## Re: PER Drainage design review

EA has reviewed the latest drainage design and calculations for the PER property sent to EA on October 22. EA concurs with the submitted calculations and approach to manage the 100-year runoff from the 3975 Elm Avenue property. However, the pre- versus post-development ponding conditions have still not been quantified along the 3975 Elm Avenue/PER property line to show improvements to drainage conditions (see #4 below). The storm drain plan view layout has not changed since the last submittal but the storm drain pipe sizes have been increased and the pipe inverts have generally been lowered to decrease the water surface elevations in the system during the 100-year rainfall event. Additionally, a TideFlex valve has been added to the outfall of the storm drain system which conveys water from the 3975 Elm Avenue property. The following are EA comments provided to you on October 2 (in black) followed by EA's observations of the revised October 22 submission in red:

4. Pete met with Mr. (b) (6) on 9/24 to discuss drainage patterns of the 3975 Elm Avenue property. Attached is an annotated C2 sheet indicating the drainage patterns on the property as des

## SECTION A-A

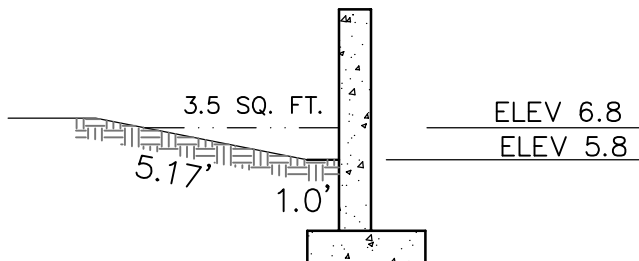
3. Once the HGLs are corrected, it will be important to check the HGL at each manhole/flushed end section (FES) along the PER/3975 Elm Avenue property line to make sure water is not ponding along the proposed retaining wall. As a suggestion, it appears that the storm drain could be lowered to accommodate total capture of runoff from the 3975 Elm Avenue property with no backup. See attached "property line" pdf for concept. Please provide similar cross sections at critical points along the retaining wall for review (especially at STMH-4). Mr. (b) (6) is concerned with additional flow/velocity along the 3975 Elm Avenue property undercutting the existing concrete pad on his property. A cross section with HGL shown (similar to the attached pdf) may ease those concerns.

The HGL at each manhole/FES along the 3975 Elm Avenue/PER property line are contained within the existing ditch. There are 5 FESs along the property line that collect runoff from the 3975 property ranging in size from 12 inches to 36 inches. Water will pond in the ditch while the storm drain is flowing full during the 100-year storm event up to 1 foot as runoff enters the FESs.

## CONCLUSION:
